No. 2518, Rev. I  
ATA Code 28-20

**SUBJECT:** FUEL - REPLACEMENT OF THE FUEL STRAINER SPRING AND HOUSING PLATE

## Service Bulletin No. 2518, Rev. I

**Figure 1**

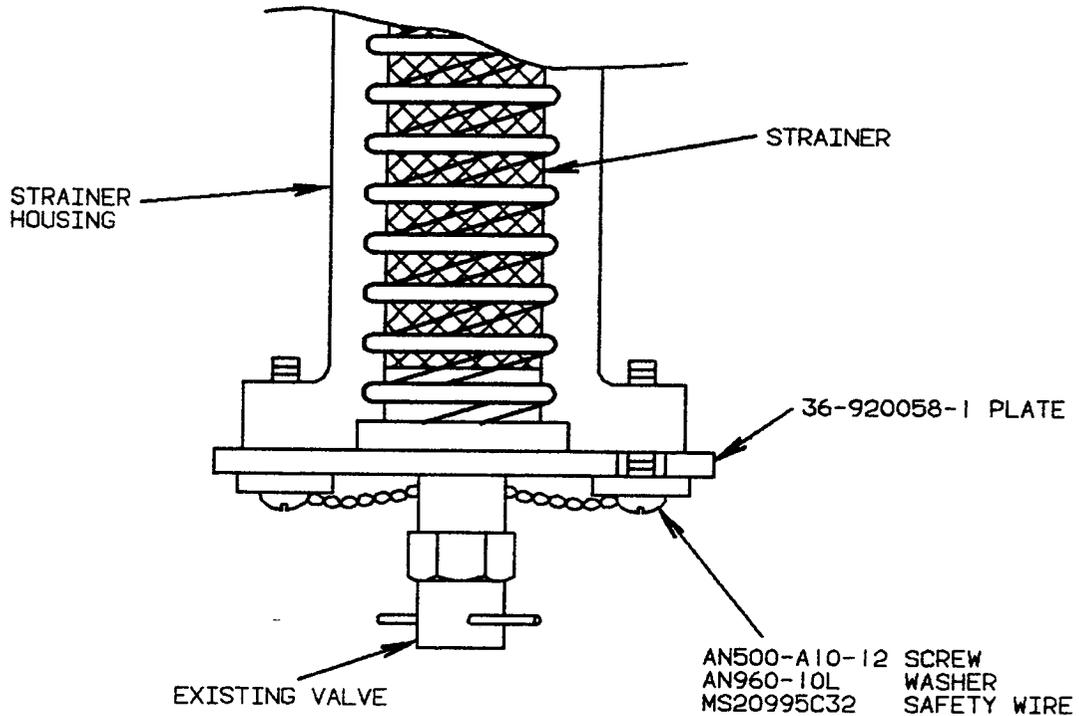
**SYNOPSIS OF CHANGE:** Revised EFFECTIVITY to include additional serials; COMPLIANCE; modified illustration in ACCOMPLISHMENT INSTRUCTIONS to clarify strainer installation; corrected pipe thread sealant part number.

**REASON:** This Service Bulletin is being issued to replace the fuel strainer spring and housing plate with an improved housing plate. The new plate and spring come as one assembly and will prevent the strainer screen from being installed incorrectly. An incorrectly installed strainer screen may allow unfiltered fuel to enter the fuel system. Unfiltered fuel may contaminate the engine fuel system and cause engine power interruptions.

1. Turn the fuel selector to the OFF position.
2. Gain access to the fuel strainer and remove the existing fuel strainer housing plate and fuel strainer spring from the bottom of the fuel strainer. See Figure 1. Remove and retain the valve from the housing plate and retain the attaching hardware. Discard the mounting plate, gasket and spring.
3. Use LOCTITE 592-31 (PST 592) to coat the drain assembly threads and install the valve into a new P/N 36-920058-1 housing plate. LOCTITE 592-31 (PST 592) is available through a BEECHCRAFT Authorized Outlet or may be procured from local sources.
4. Install a new P/N 35-921181 gasket on the new housing plate, place the strainer into

the spring (attached to the new plate) and attach the plate to the strainer housing using the two screws and washers which were removed in Step 3. Safety the two screws with P/N MS20995C32 safety wire (obtain locally).
